ALL SAINTS' CHURCH

NGALO

ADDENDA.

MAY 22nd. 1928.

NGAIO CHURCH VESTRY

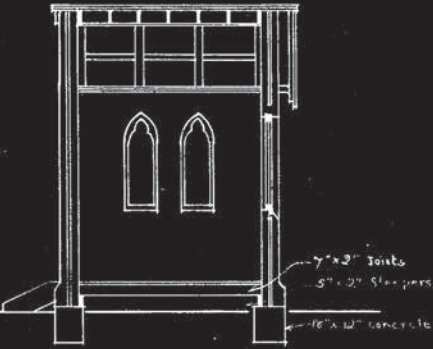
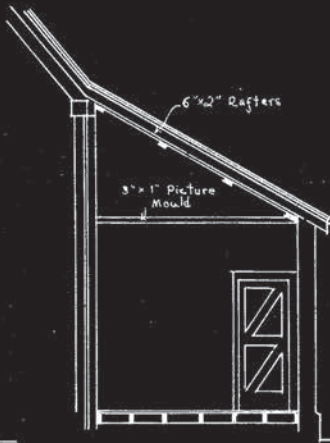
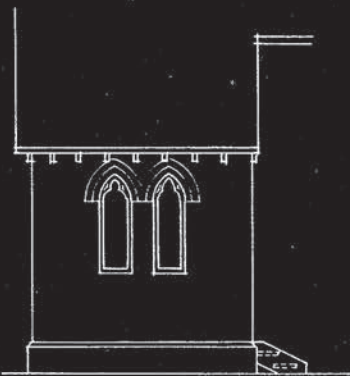
VESTRY. A separate price is required for a vestry to be built on the N.E. corner of the Nave. Its plan and construction shall be as shown on the drawing attached to this specification, the materials and workmanship being in strict accordance with the main contract. The price given shall allow for the omission of the screen forming the present Vestry under tower. The three walls shall be 11" thick matching the side walls of church, excepting that the mortar used shall be cement mortar. The two doors shall be each 6'6" x 2'6"x 2" thick framed and ledged, with the top and bottom rails rebatted for sheathing,

each shall have an approved latch of the value of 10/- and the outside door shall be provided with a Yale type of lock valued at 12/6. The steps to the outside door shall be heart of Jarrah, 10" x 2" treads housed into 2" thick stringer and resting on 6" x 6" H.T. or H. Jarrah blocks at bottom. The risers shall not be more than 7" and if this be not sufficient to reach the ground, the ground shall be made up in an approved manner to meet them.

There shall be three windows (one to open) matching the other windows in church. All shall be left complete and watertight.

The outside door must open inwards as eventually it will be an inside door. To overcome the chance of rain beating in, the styles and head shall be grooved as in casements. The rebate in which the door is hung, shall be deeper than usual and the sill shall have a stout metal strip along it to prevent drift and along the lower edge of bottom rail, there shall be a weathering piece overhanging this strip, and any other item that may be required to make this door storm proof, shall be provided and fixed. The ceiling shall be of plaster boards with 4" x $\frac{1}{2}$ " battens, cutting it up into even panels. Round the three higher walls shall be fixed a 3" x 1" picture mould, lining in with the chamfered top plate of the lowest wall.

SEPARATE PRICE REQUIRED FOR THIS.
